REMARKS/ARGUMENTS

(For the Examiner's convenience the paragraph numbers below correspond to the paragraph numbers in the Office Action.)

FIG. 5

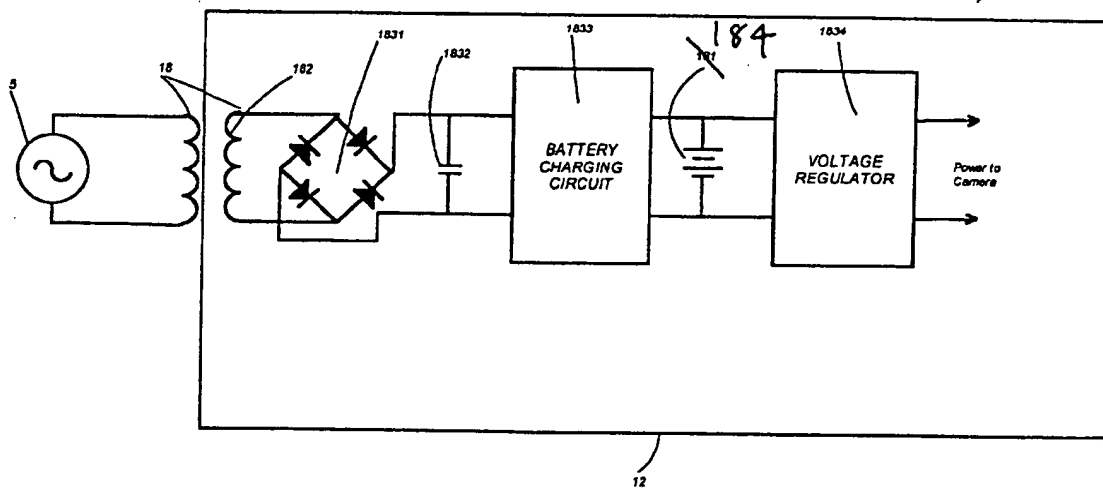
5. The drawings are objected to as failing to comply with 37 CFR 1.84(p)(4) because reference character “181” has been used to designate both a power switch (Figure 1) and a battery (Figure 5).

The attached sheets of drawings include changes to Figs. 5 and 8. The sheet including Figs. 4 and 5, replaces the original sheet including Figs. 4 and 5. In Figure 5, reference number 181 has been amended to 184. The sheet including Fig. 8, replaces the original sheet including Fig. 8. In Figure 8, reference number 373a for the antennas has been added.

Applicant has amended reference number 181 to 184 on Figure 5. Applicant has also noted that the battery had been associated with reference numbers 181 and 183 in the specification and has corrected these typographical errors also.
